JUNE 21, 2021 ZBA AGENDA LEGAL NOTICE

June 21, 2021 REGULAR AND SPECIAL ZBA MEETING MINUTES

HA JOB: #20312
DATE: March 11, 2021
REVISED: June 3, 2021
SUBJECT: Compensatory Flood Plain Analysis –
The Residences at O’Shea Field, 40 Oak Street, Peabody, MA 01960

Figure 1 FIRM Flood Zones

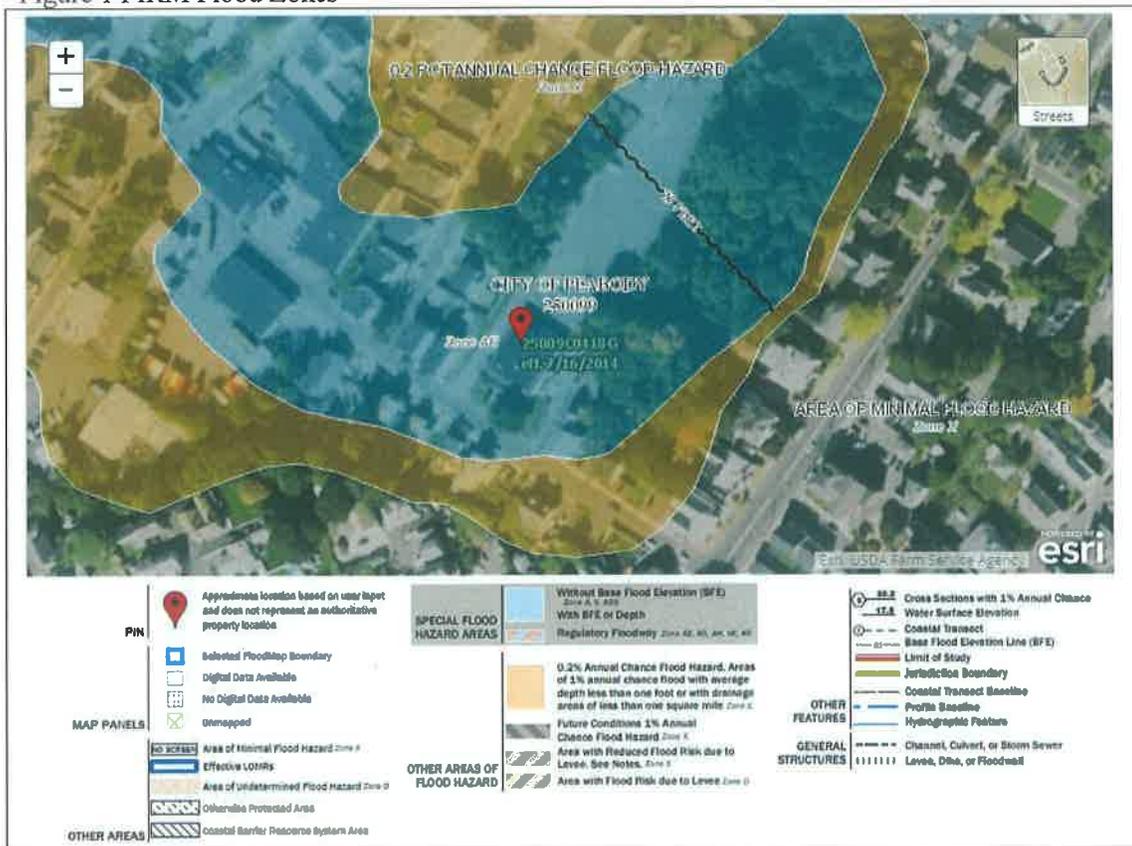
Janet Carter Bernardo, PE, Horsley Witten Group: “The Applicant has indicated that the entire site is located within the 100-year flood plain. HW recommends that the Applicant provide compensatory storage calculations to ensure that the proposed development does not negatively impact the existing flood plain. The calculations should clearly indicate the storage of flood water beneath the buildings. HW further recommends that elevations of the buildings be provided to verify that flood waters can flow under the buildings without any restrictions.” (Letter to City Engineer dated August 31, 2020, Page 6, Item 11b).

Refer to the FEMA Flood Mapping FIRM 25009 CO418G (Effective July 16, 2014) which delineates the locus of work as part of Flood Zone District AE, Elevation 27 (NAVD 1988 Datum). The extent of the Flood Zone is shown on Figure 1.
